RPC Module Signal and HV Connections

(October 27, 2008)

Changguo Lu, Kirk T. McDonald

Princeton University

Lu's Version of the Interconnects

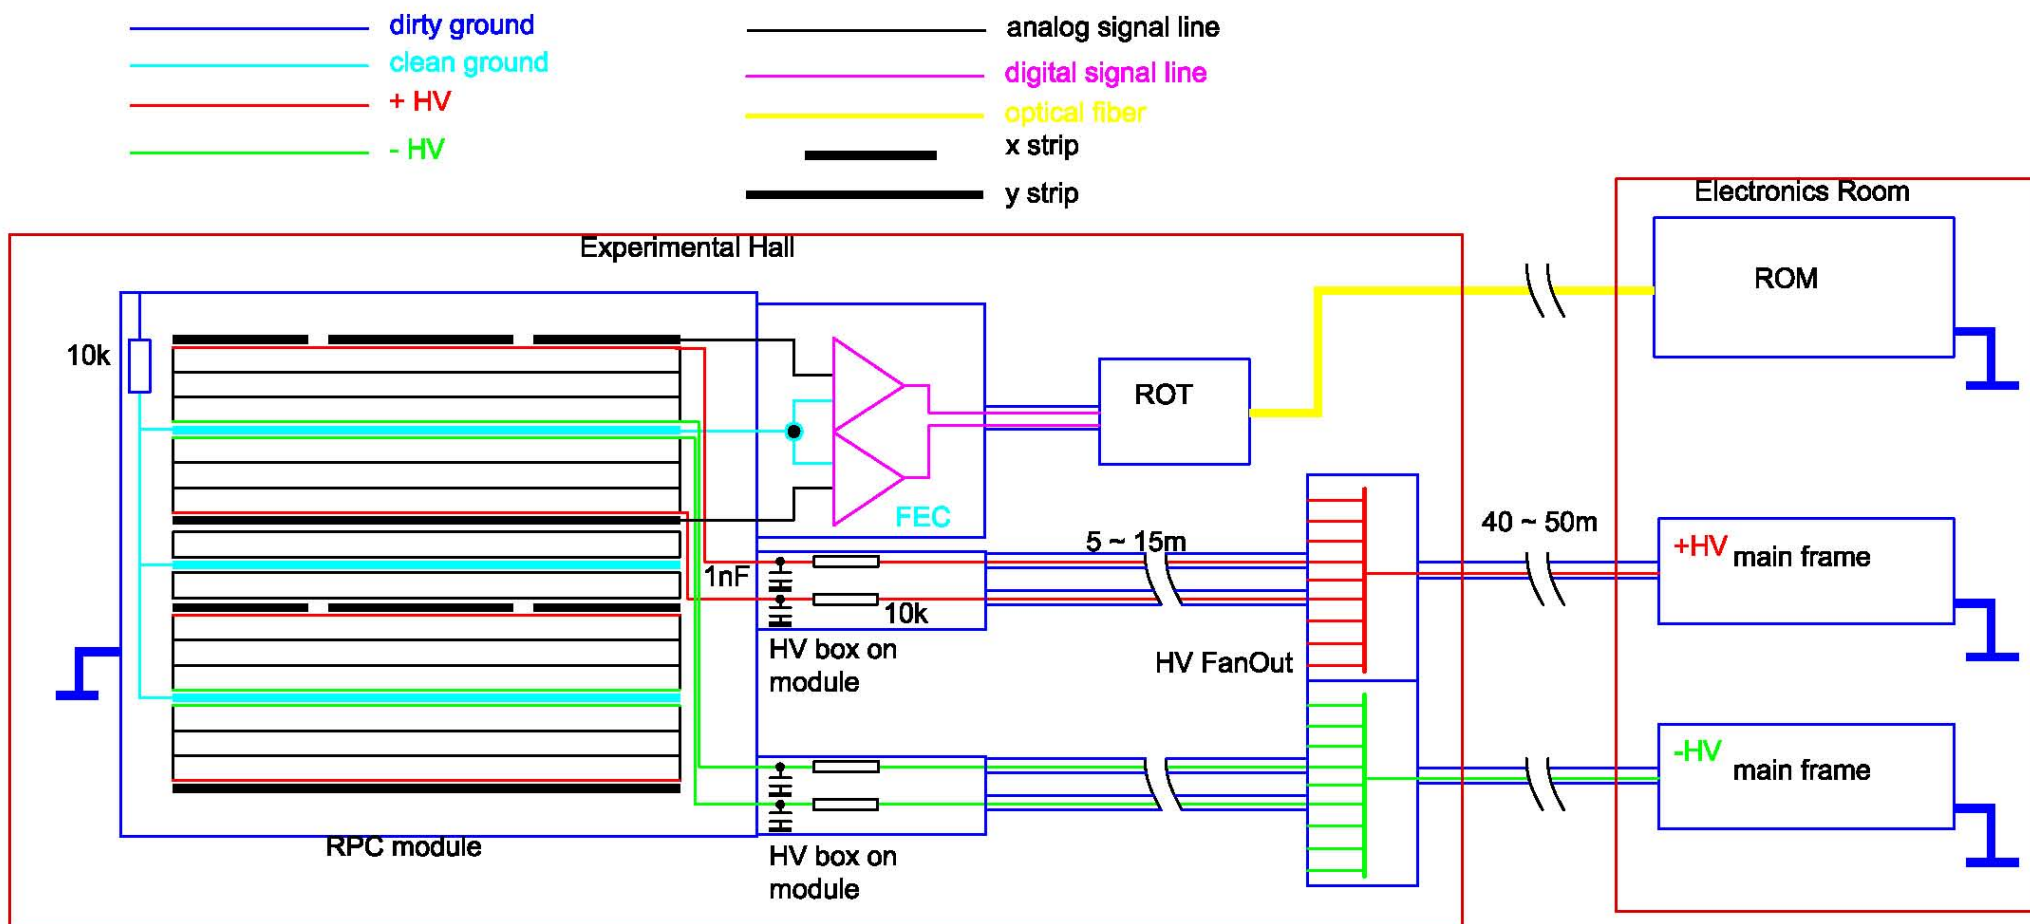
Basically the same as McDonald's version.

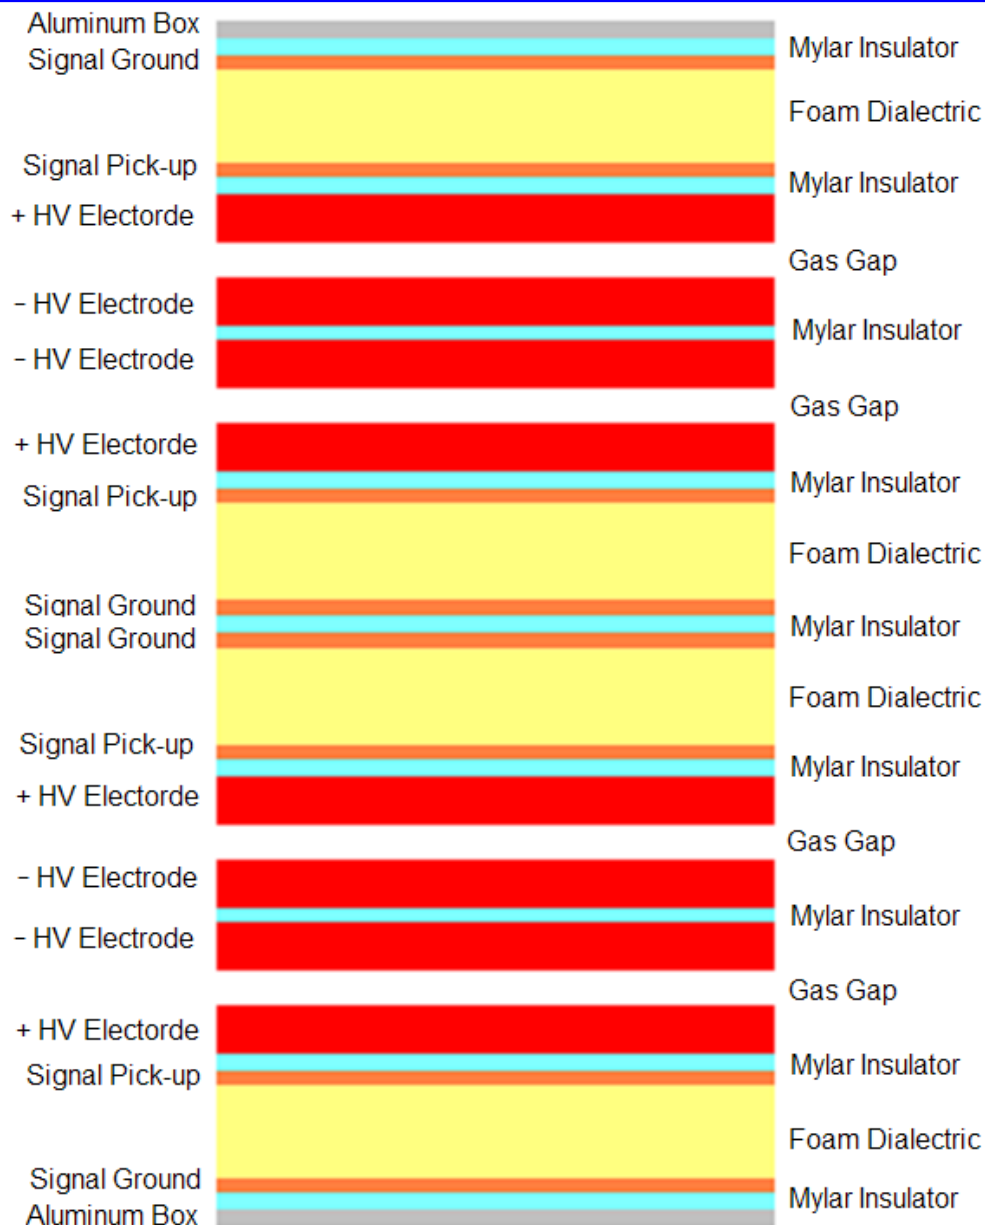
- Hi, Chris and Xiaonan,
- The ground block diagram of DayaBay RPC is shown as below if I have a correct understanding. But I am not sure that a dashed line with a RED question mark in the middle of the diagram should be connected or not. In general, the HV cable shield connected just with one end to ground, so the resistance of the signal ground to quiet ground is a resistance of 15m FEC ground wires, which could not be a good capability of EMI because its resistance is not small enough.
- Could we use a special wire with a small enough resistance to RPC signal ground, as shown a brown line in below picture, to increase the EMI capability?

From Jon Link, DocDB #2644

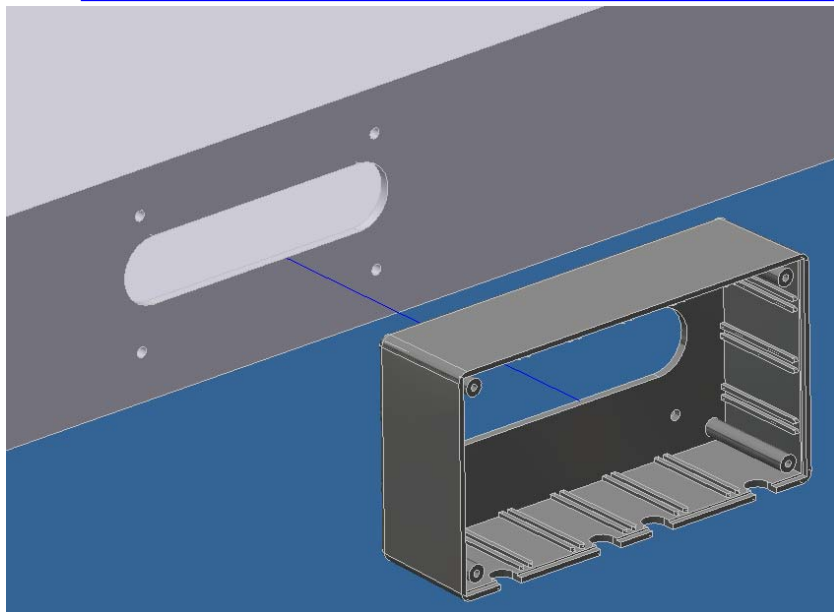
Signal Ground electrode between the -HV bakelite electrodes is missing.

There is no electrical reason to split the signal Ground between the central pair of foam dielectric layers.

From Jon Link, DocDB #2644

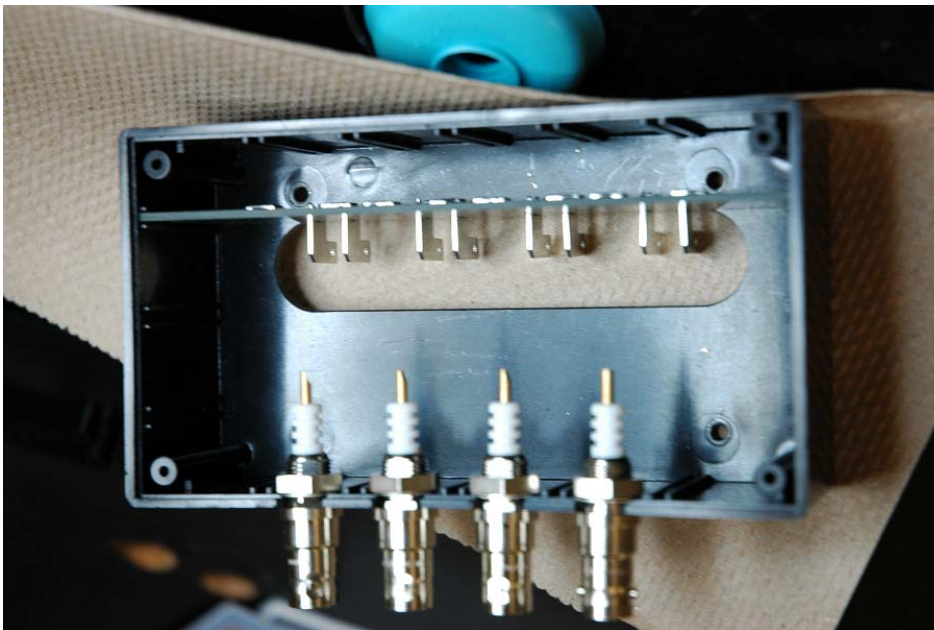
It would be better if the HV Interface Box had a metal housing, rather than plastic.

If plastic, the HV lines are exposed to the external electrical environment over a few cm, and could pick up unwanted noise.

A concern is that a metal box would connect the "clean" ground of the HV crate to the "dirty" ground of the RPC modules in the experimental Hall.

This is not a concern if the "clean" ground is properly done, via a Faraday cage around the electronics room, and all coaxial cables entering/exiting the cage via bulkhead feedthroughs.

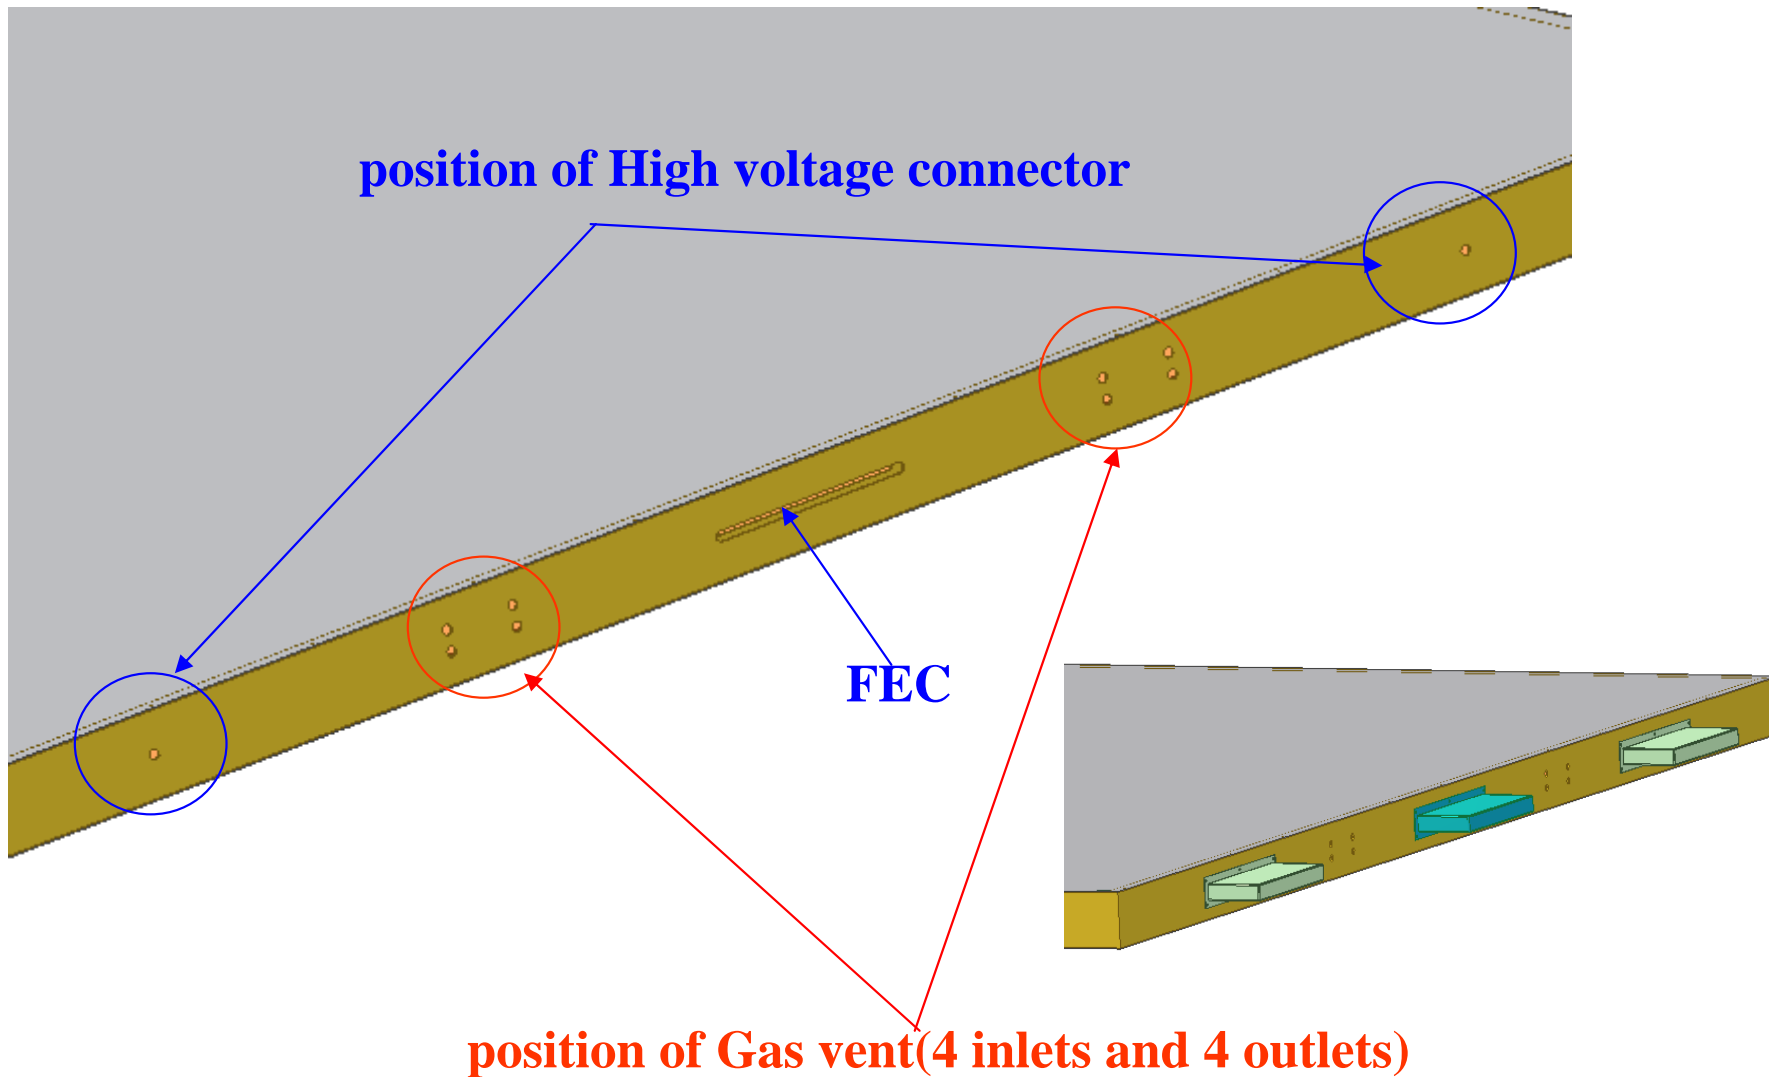
Proposed layout is fine, assuming that the FEC boxes and HV interface boxes provide electrical shielding.
